131 Rumford Avenue

Subject: **Transportation Peer Review Responses
Proposed Marijuana Use
131 Rumford Avenue
Newton, Massachusetts**

Re: Response to Comments- Traffic Study Peer Review
Proposed Marijuana Dispensary
131 Rumford Avenue
Newton, Massachusetts

Re: Special Permit – 131 Rumford Avenue

Attachments: Site grading diagram

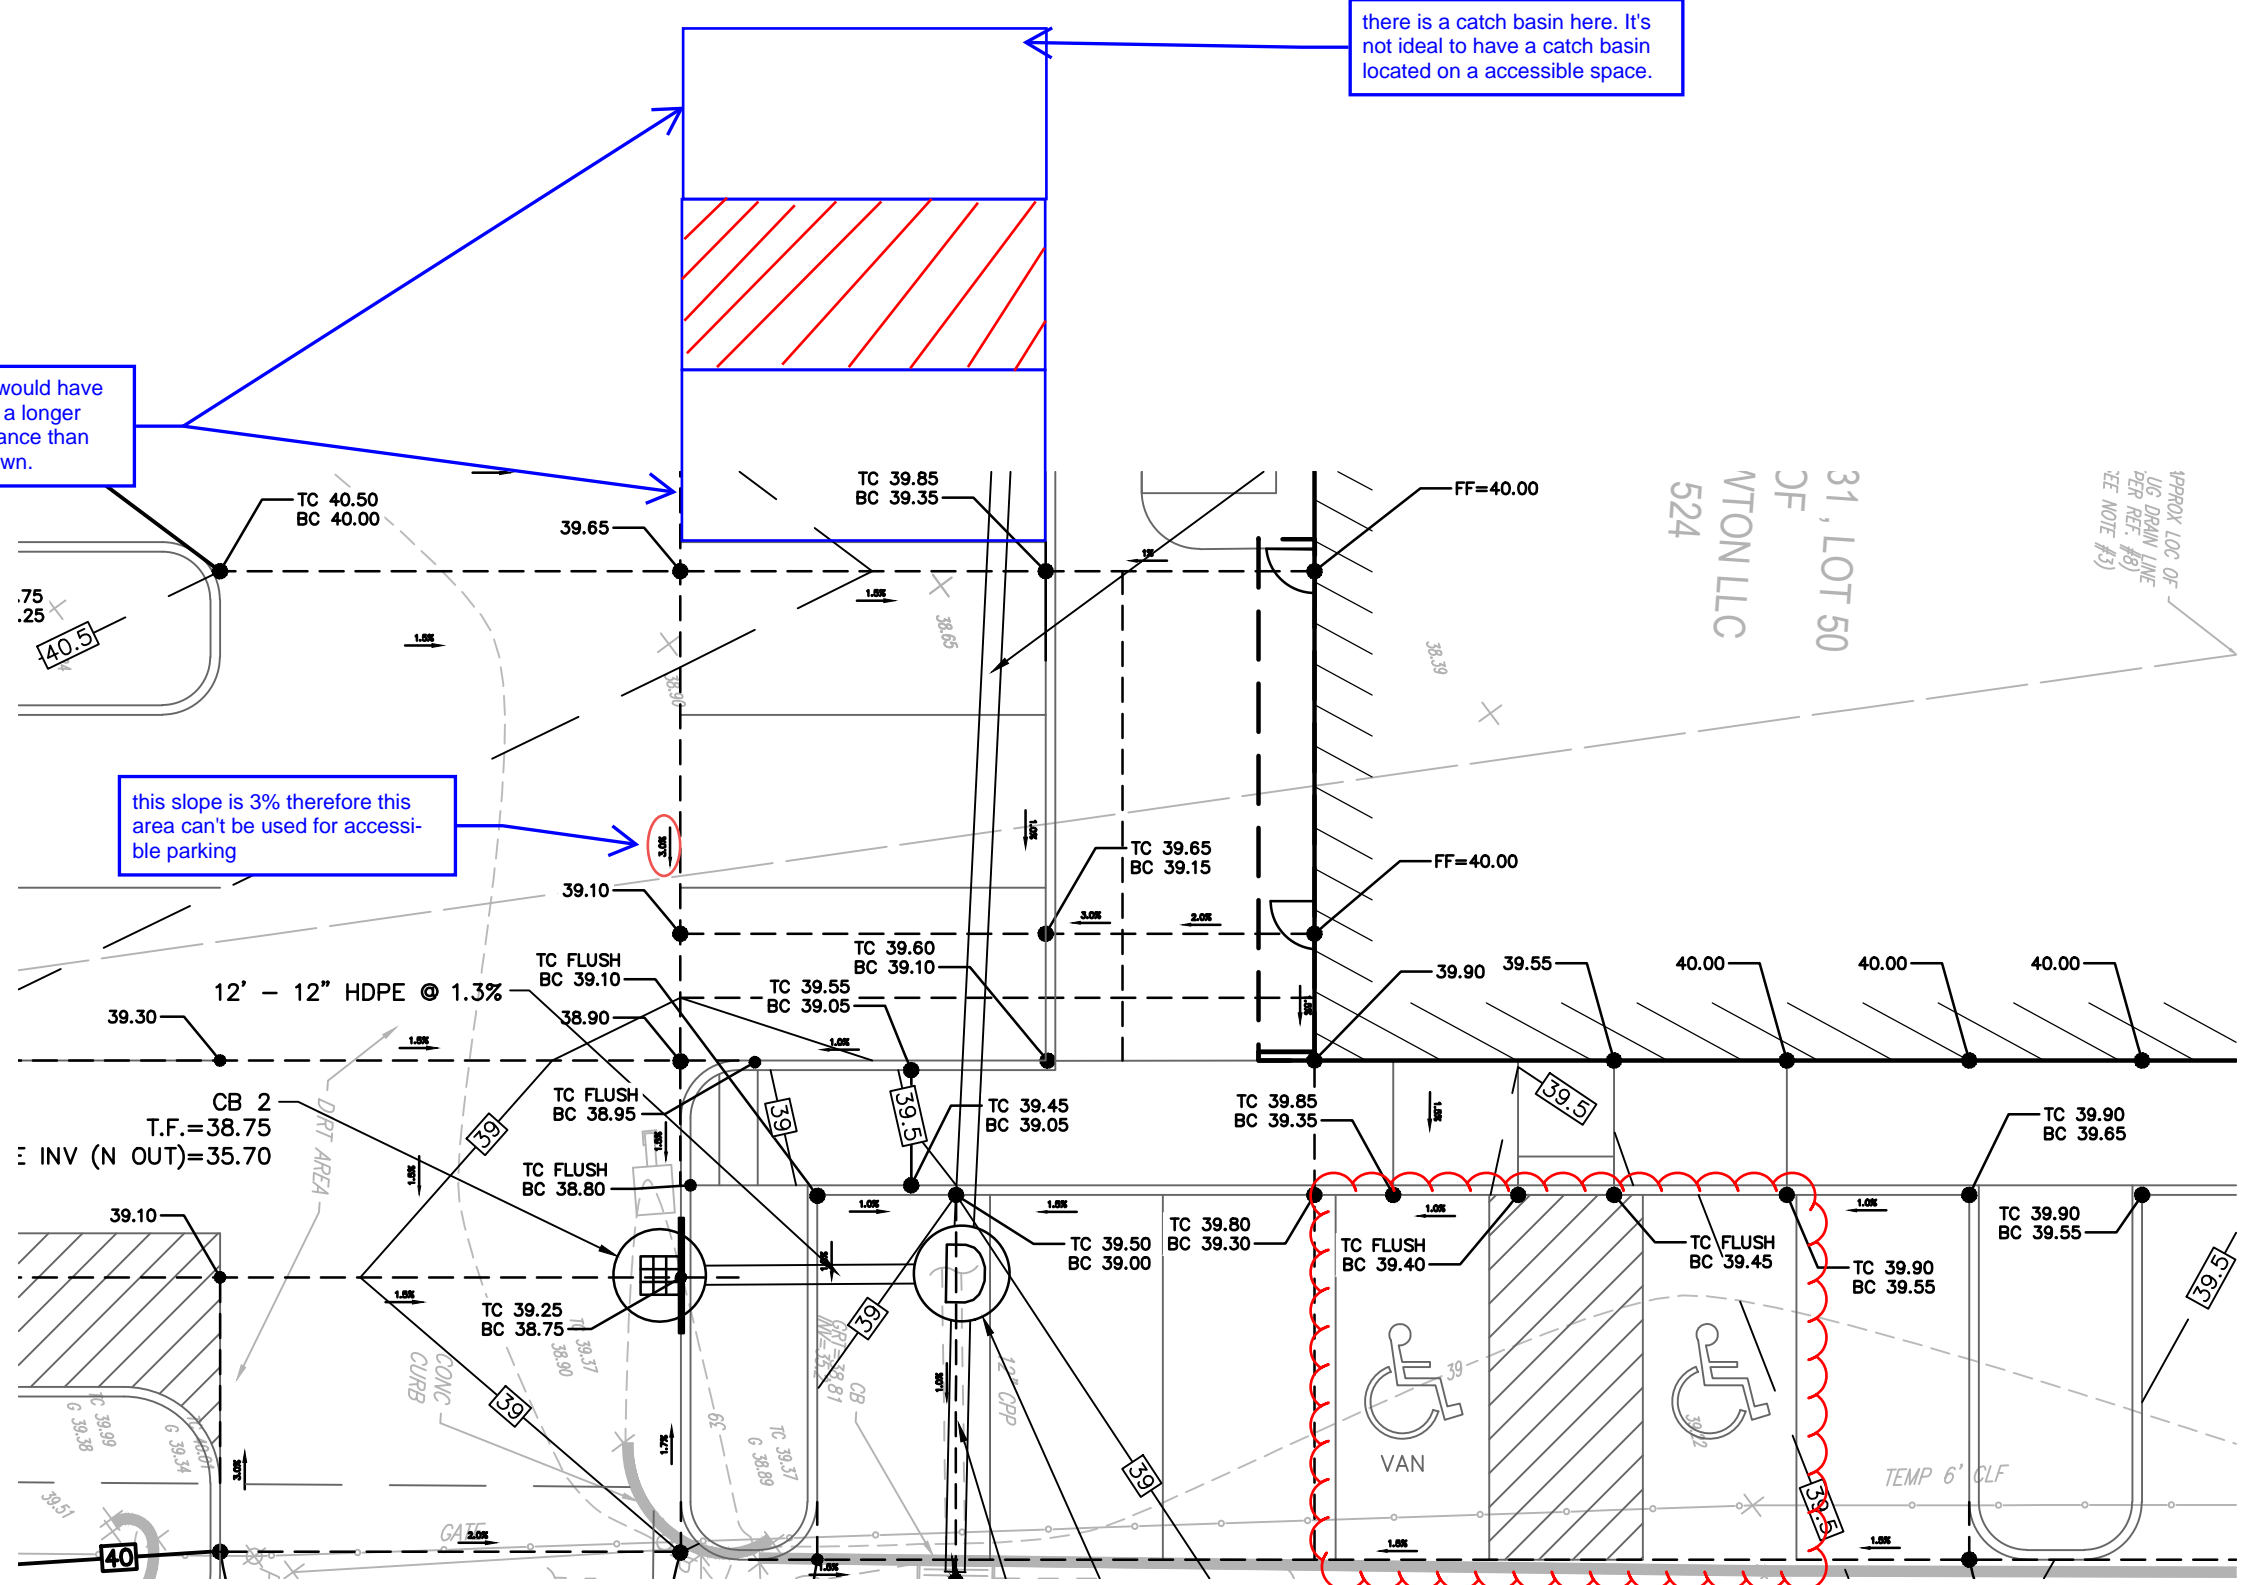
- 5. Please clarify why ADA-compliant grades cannot be maintained at this location. It appears there is sufficient room to achieve these grades.*

there is a catch basin here. It's not ideal to have a catch basin located on a accessible space.

accessible parking would have to be here, which is a longer distance to the entrance than where currently shown.

this slope is 3% therefore this area can't be used for accessible parking

No slope in this area is more than 1%

The slope along the southern end of the parking spaces in front of the door is 3% for site drainage purposes. This is not an acceptable slope for an ADA-compliant accessible space. Please see the attached diagram for further clarification.
